DRB1 RECOMMENDATION MEETING: OCTOBER 2, 2017

DRB2 RECOMMENDATION MEETING: APRIL 2, 2018

DESIGN REVIEW

SDCI 3024352 - 6416 15TH AVENUE NW

MASSING OVERVIEW

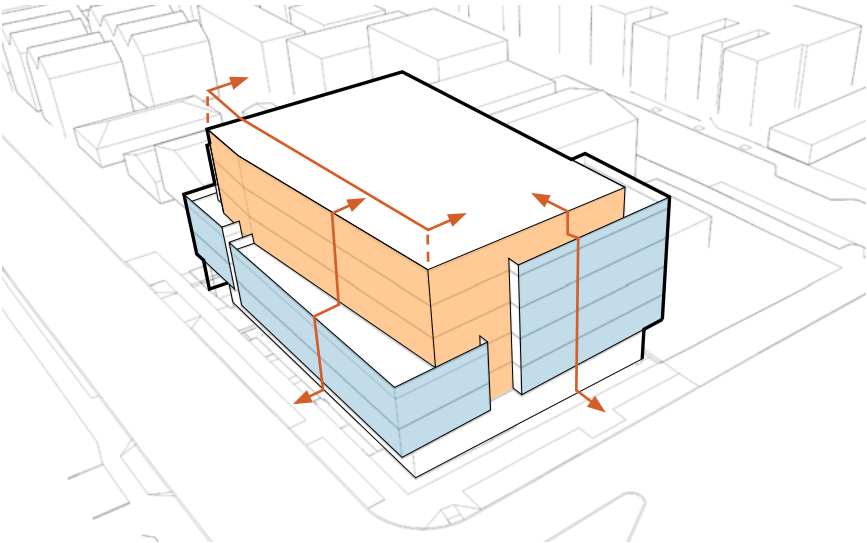
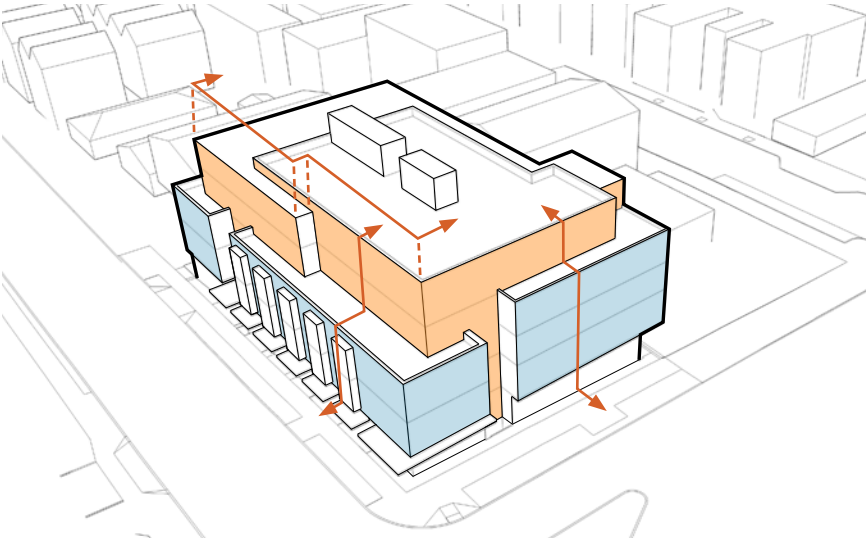
- Provide meaningful design with interesting proportions.
- Shift the bulk away from the LR3 zone.
- Minimize the height.
- Provide strong presence at the corner.
- Design street level to respond to uses.

DRB1 MASSING - TRANSITION ALONG NW 65TH STREET & EAST PROPERTY

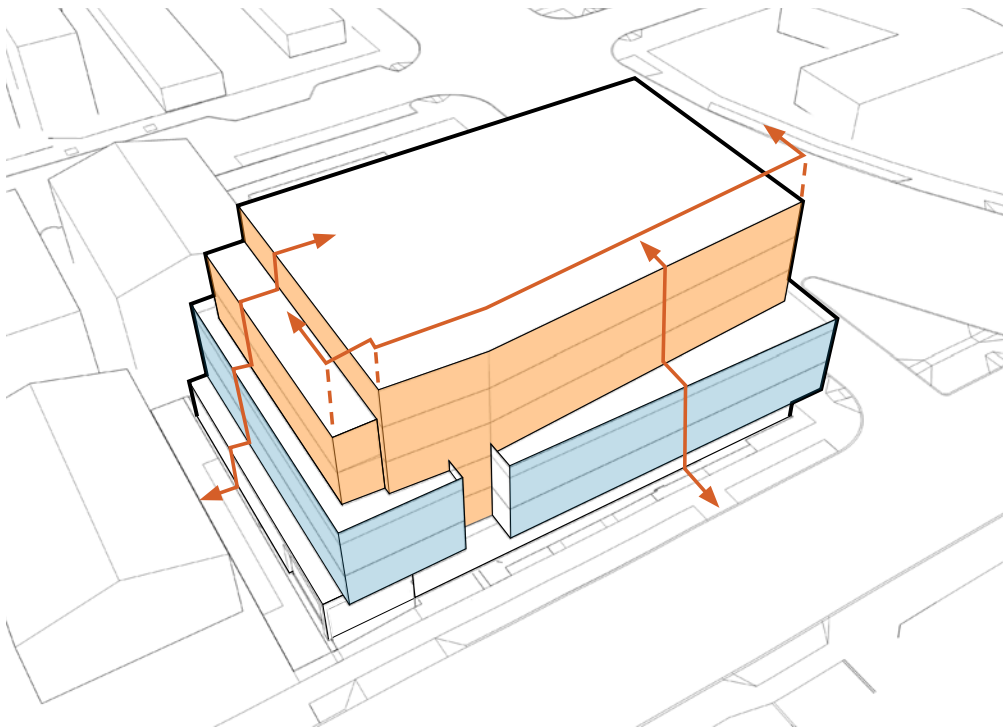
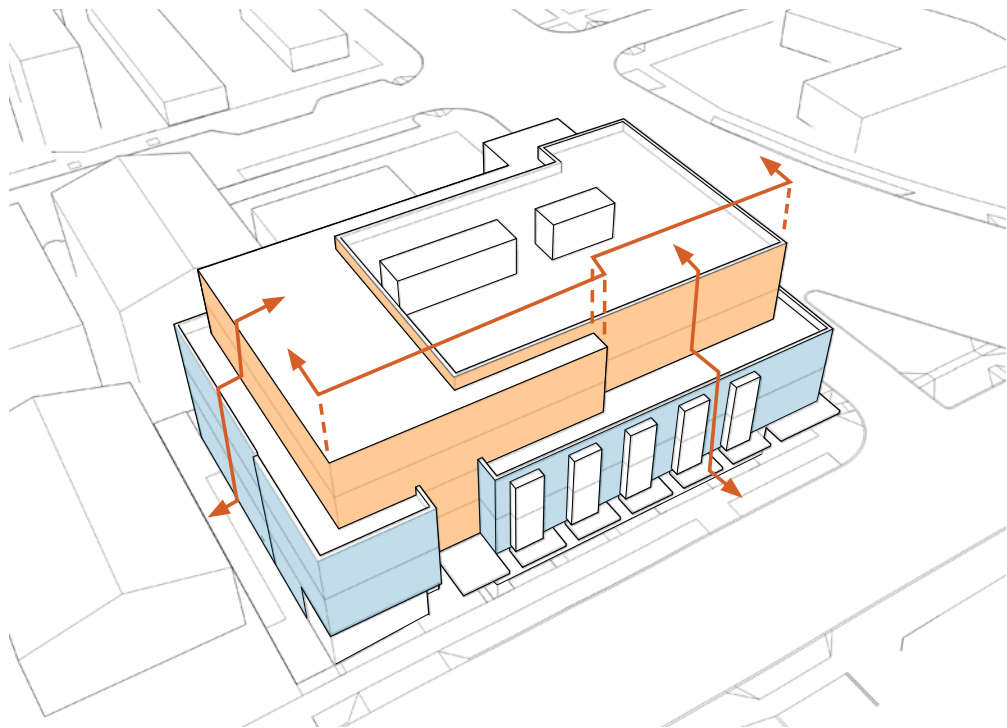
- a. The proposed project does not relate to the context of the surrounding sites and is too tall. (CS2.D.3 & 4)
- b. More relief should be provided at the zone edge by stepping the building and setting back the upper floors. (CS2.D.1, 3, 4 & 5)

- a. The building has been revised to 5-stories, rather than the previous 6-story proposal. The 3-story massing along NW 65th St relates to the scale of Ballard High School. The windows at the bay windows provide similar scale to the high school windows.
- b. The massing has been simplified to comply with the MHA 55' zoning setback requirements. The building is permitted to be 10' from the LR zone up to 65'. The 4-5 floors are setback 16' to provide additional relief.

STREET LEVEL TREATMENT

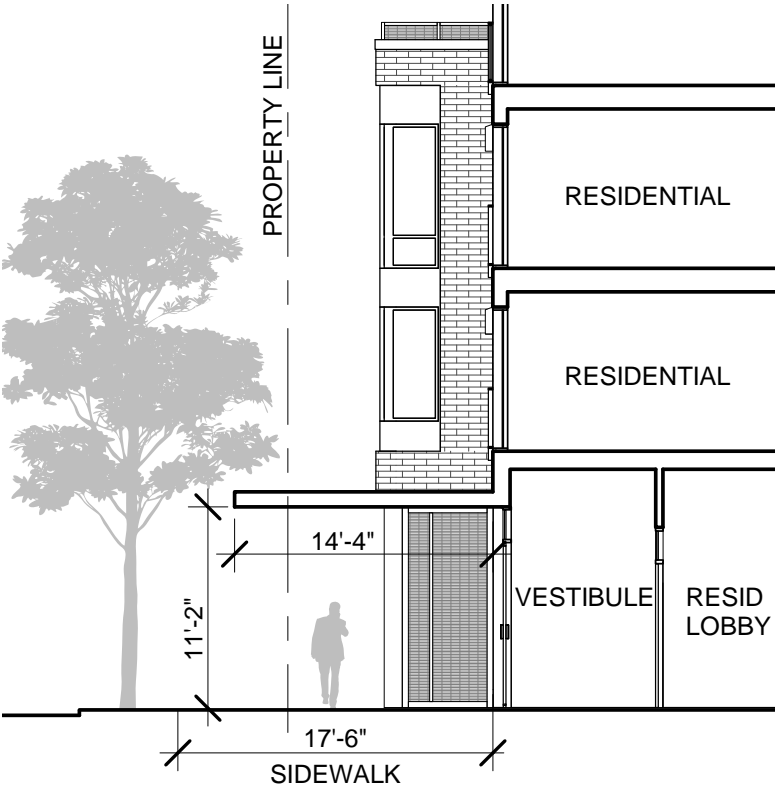
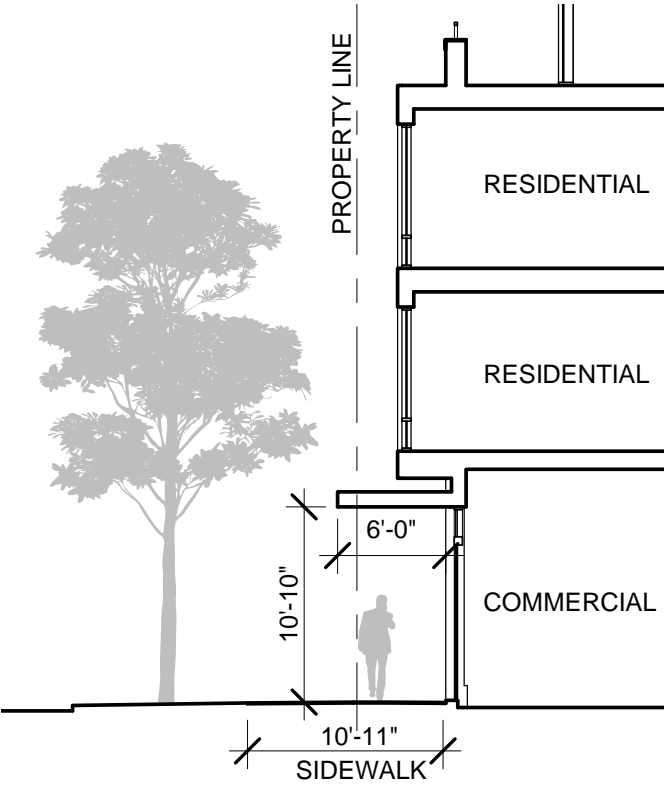
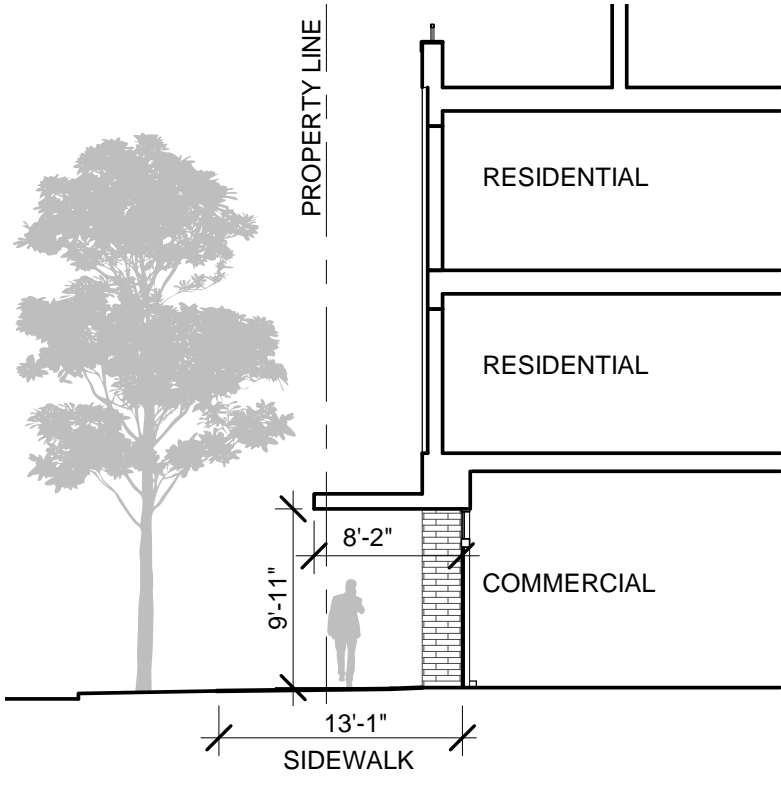
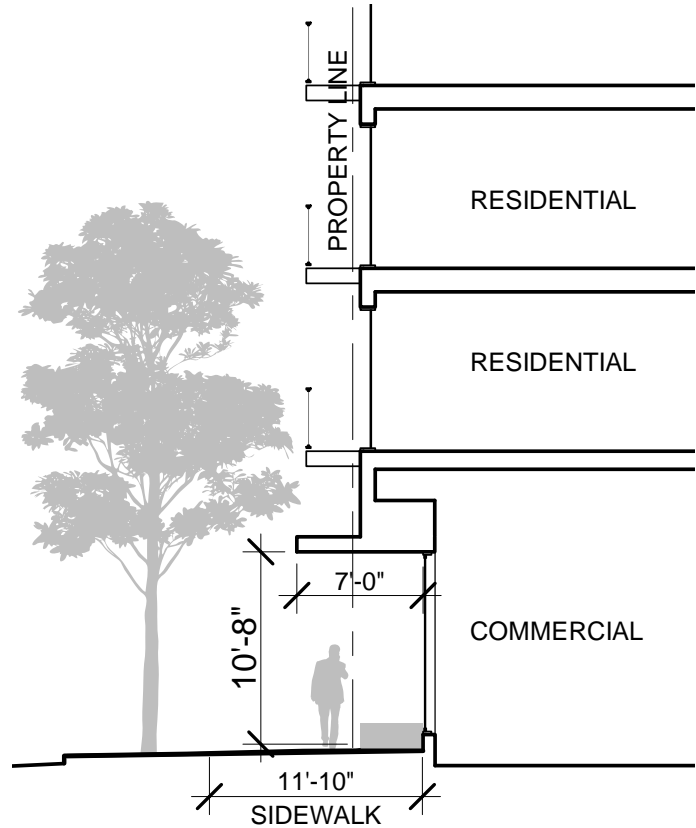
- b. Design the residential entry and the commercial entries to be different. (PL3.A.1)
- c. Along NW 65th St, transition the design with the uses along NW 65th St. (DC2.E.1)
- d. Screen the staging area for solid waste storage, if it is located along the east property line. (DC1.C.4)

- b. The residential entry is recessed 11'-3" from the property line and a deeper canopy is provided. The primary commercial entry is located at the corner, oriented toward NW 65th Street. Secondary commercial entries are located on NW 65th Street and 15th Avenue NW. Black metal canopies with wood tone soffits and integral downlights are located along the commercial and residential entries for a cohesive street frontage.

LR TRANSITION - EAST ELEVATION

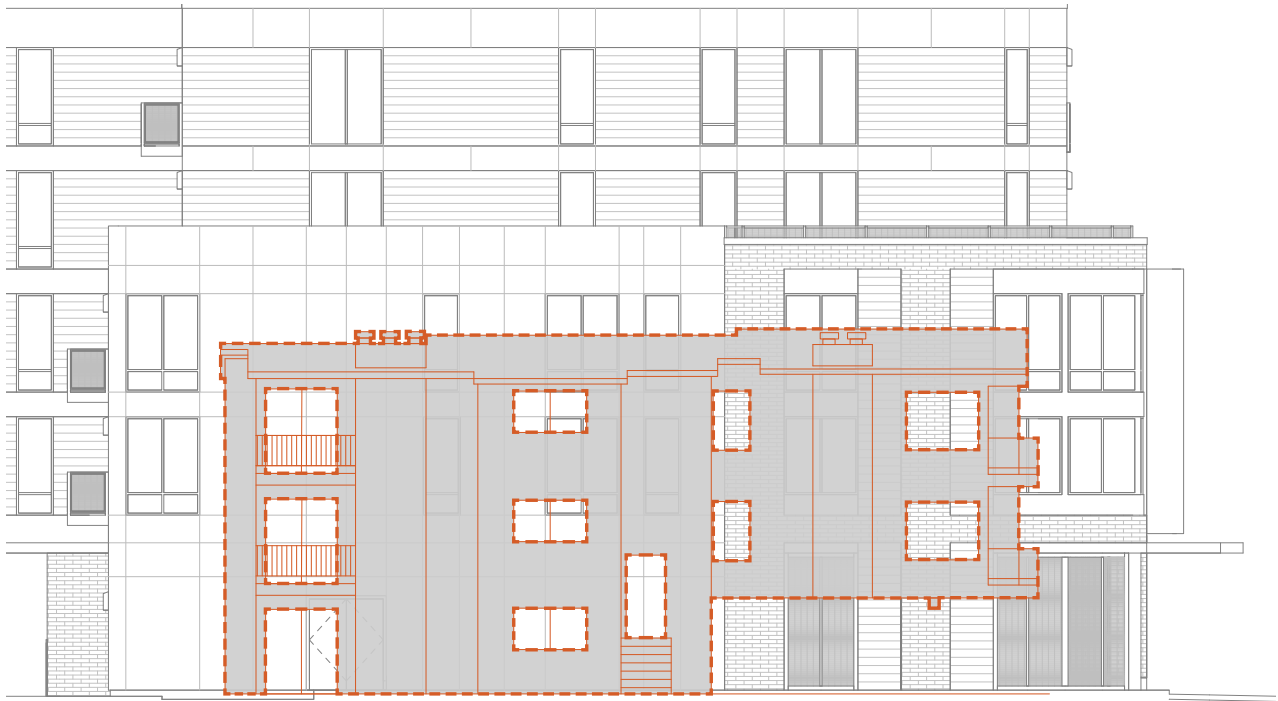
- b. Provide more relief at the zone edge by stepping the building and setting back the upper floors. (CS2.D.3&4)
- i. The roof amenity area should be configured away from the LR zone and focus the active rooftop uses at the SW corner. (CS2.D.5)

- b. The building has been revised to 5-stories, rather than the previous 6-story proposal. The 3-story massing along NW 65th St and the east property line relates to the scale of Ballard High School and the context in the LR zone. The massing has been simplified adjacent to the LR3 zone with the reduction of 1-floor and complies with the MHA 55' setback requirements. The building is permitted to be 10' from the LR zone up to 65'. The 4-5 floors are setback 16' to provide additional relief.
- i. The roof amenities area has been configured to the west and southwest portions of the roof as identified on the roof plan.

DEPARTURE #1

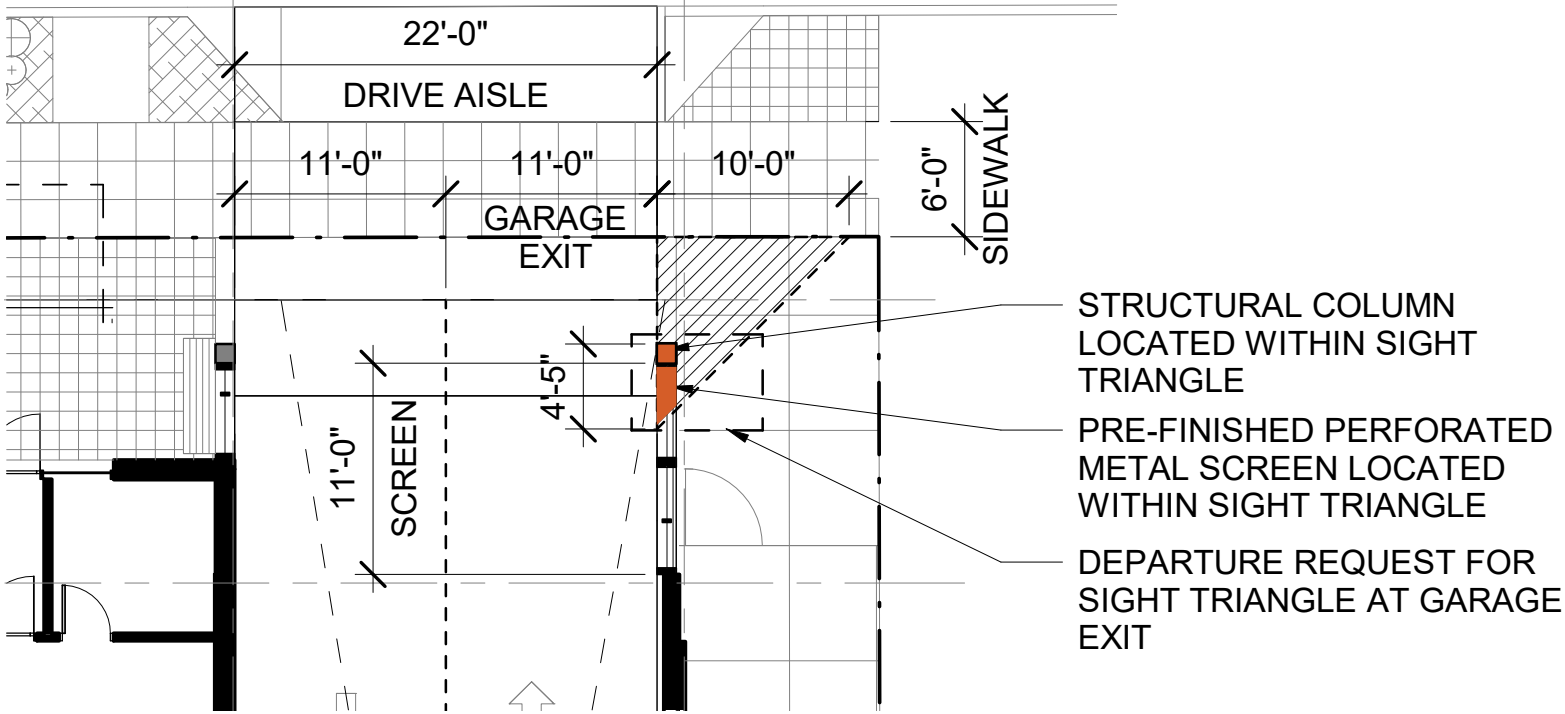
- 2. For two way driveways or easements 22 feet wide or more, a sight triangle on the side of the driveway used as an exit shall be provided, and shall be kept clear of any obstruction for a distance of 10 feet from the intersection of the driveway or easement with a driveway, easement, sidewalk, or curb intersection if there is no sidewalk. The entrance and exit lanes shall be clearly identified.
- 3. The sight triangle shall also be kept clear of obstructions in the vertical spaces between 32 inches and 82 inches from the ground.

To allow for an obstruction on one side of the sight triangle of the exit aisle in order to maintain a 22'-0" wide two-way drive aisle.

The proposed residential entry and 22'-0" wide drive aisle has been setback from the property line to provide a sight triangle at the entry and exit lanes. A structural support column is required at the northeast corner to hold up the 2nd and 3rd floor massing. A perforated metal screen will provide added protection for pedestrian traffic while providing visual continuity for circulation.
